# LANDSCAPE PEER REVIEW

**NPDC REF:** LUC20/47660

**SUBJECT\_** Peer Review of the Landscape and Visual Impact Assessment included as an appendix to the Land Use Consent Application at 1 Dawson Street, New Plymouth.

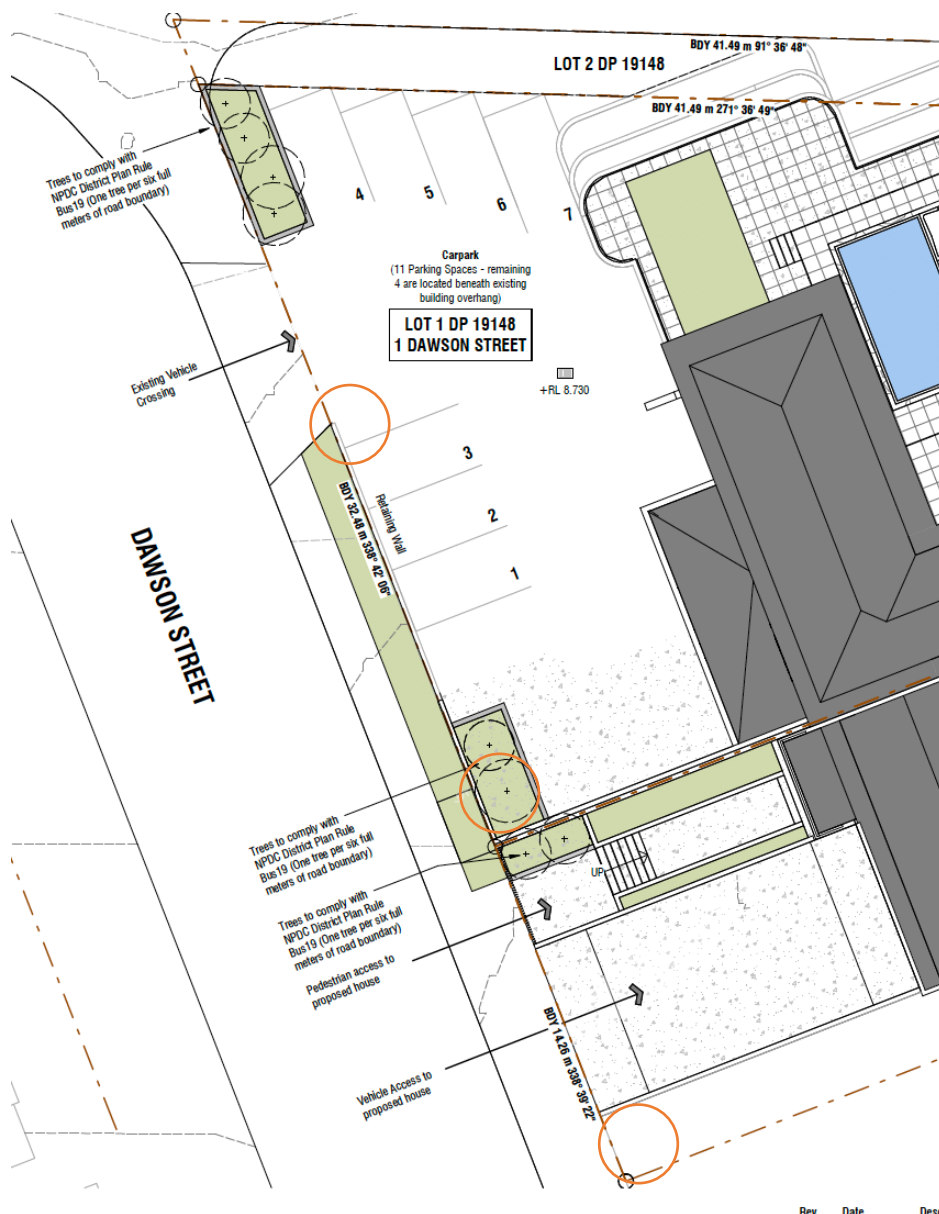
- 5.1.1. I accept the computer modelling which illustrates the over-height portion of the development will not be visible from/within the Cameron Street Viewshaft due to intervening Pohutukawa trees located on Queen Street. Therefore, there is NO CHANGE to this view.

- 5.1.2. I accept the discussion around the complexity of the Marsland Hill viewshaft. I agree the view is eclectic and cityscapes are dynamic over time. What is illustrated by the montage within Appendix B, is how the dark colour used in the montage punctuates the centre or core of the scene where built form touches the sea. In considering the character and theme of buildings around the proposal, essentially all buildings directly adjacent are of light 'coastal' colours.

- 5.1.3. I am comfortable with the proportion of the view that the proposal will remove – I consider its protrusion into the view to have an overall low effect on appreciation of the view. However, I question if there are other colour schemes that may tie in with the applicant's vision while reducing its punctuation of the chromatic palette in the area. It is possible an options analysis may be useful, with colours also taking into consideration visual effects from viewpoints/receptors closer to the development.
